UNITED STATES  
NUCLEAR REGULATORY COMMISSION  
WASHINGTON, D. C. 20555

AMENDMENT TO PROVISIONAL OPERATING LICENSE

Amendment No. 35  
License No. DPR-16

SAFETY EVALUATION BY THE OFFICE OF NUCLEAR REACTOR REGULATION

FIGURE 3.10-1

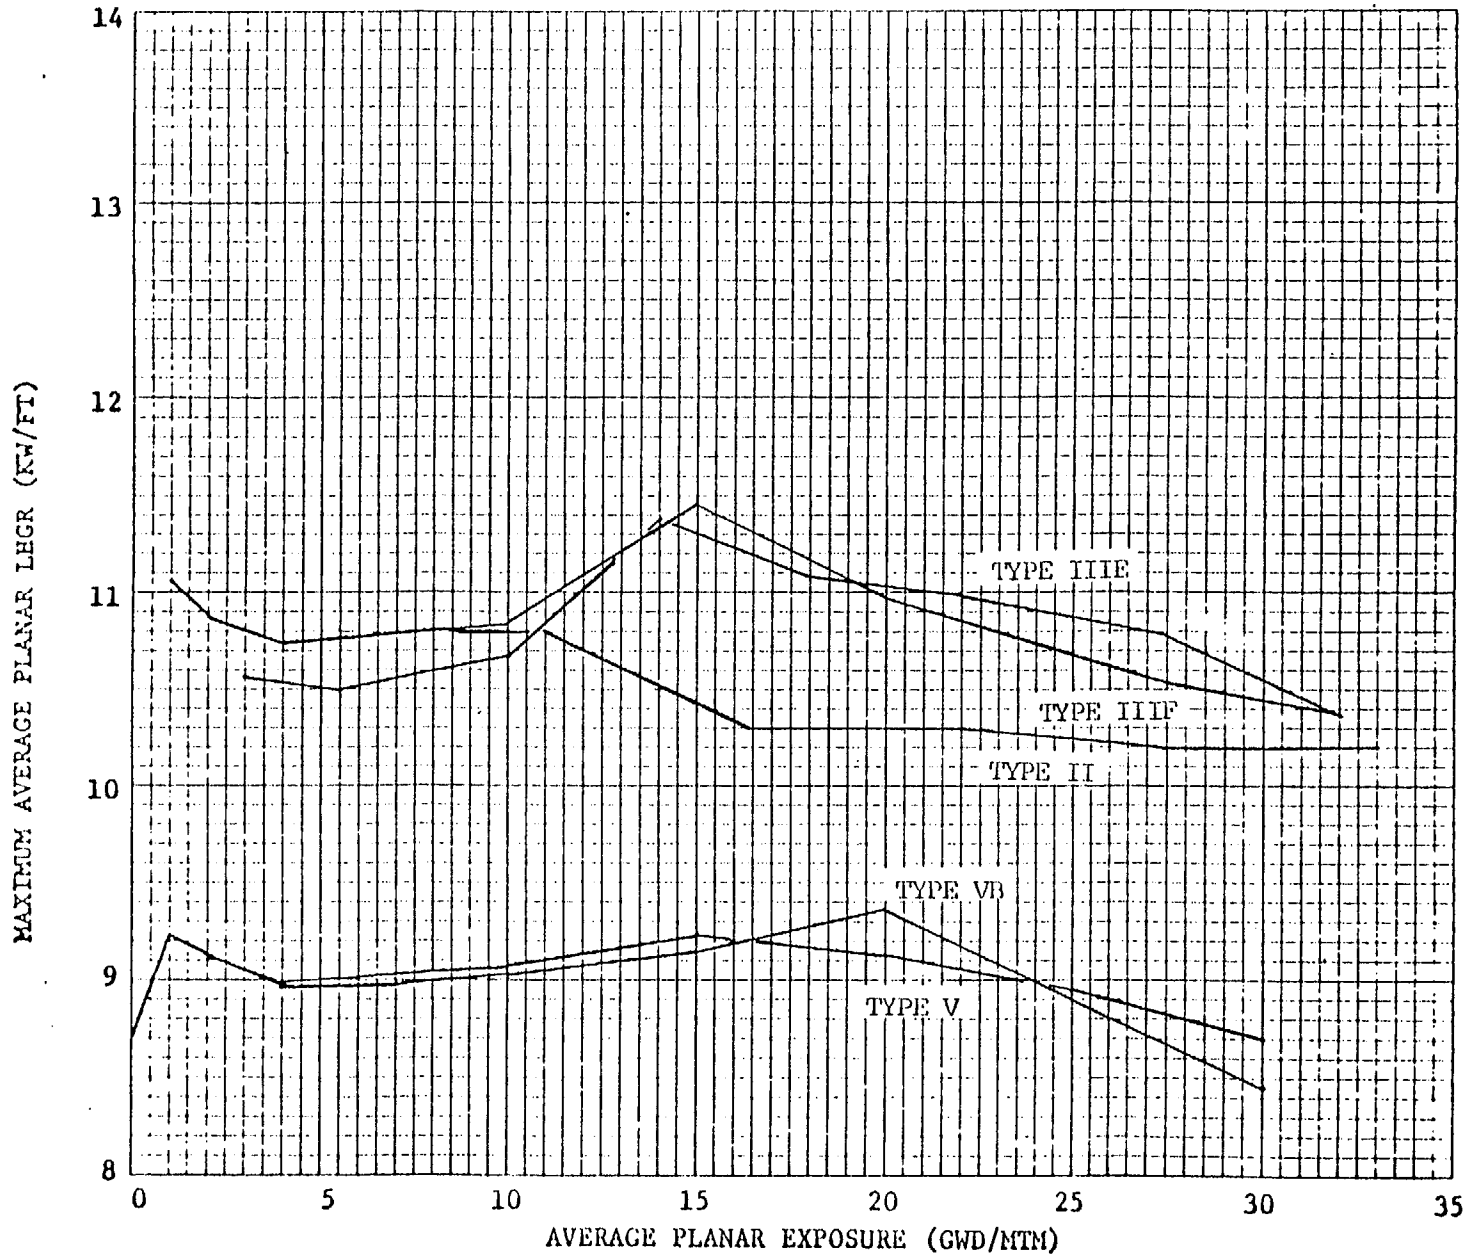
The amendment allows operation with one recirculation loop out of service using the more restrictive Maximum Average Planar Linear Heat Generation Rate (MAPLHGR) limits (originally authorized by Amendment No. 30, dated March 14, 1978), with values extended to encompass higher exposure fuel.

By letter dated May 15, 1979, the licensee provided a new set of MAPLHGR curves. These curves extend the previously approved MAPLHGR curves of Amendment No. 30 for higher exposures. JCP&L's application dated May 24, 1979, requested a license amendment to incorporate the extended curves in the Technical Specifications. We have reviewed the newly proposed MAPLHGR limits and have concluded that they are based on calculational methods previously accepted; they do not change MAPLHGR limits previously found acceptable but only extend the previous calculations to higher fuel exposures and, therefore, are acceptable.

INTERIM MAPLHGR LIMITS  
FOR 4 RECIRCULATION  
PUMP OPERATION IN OYSTER CREEK
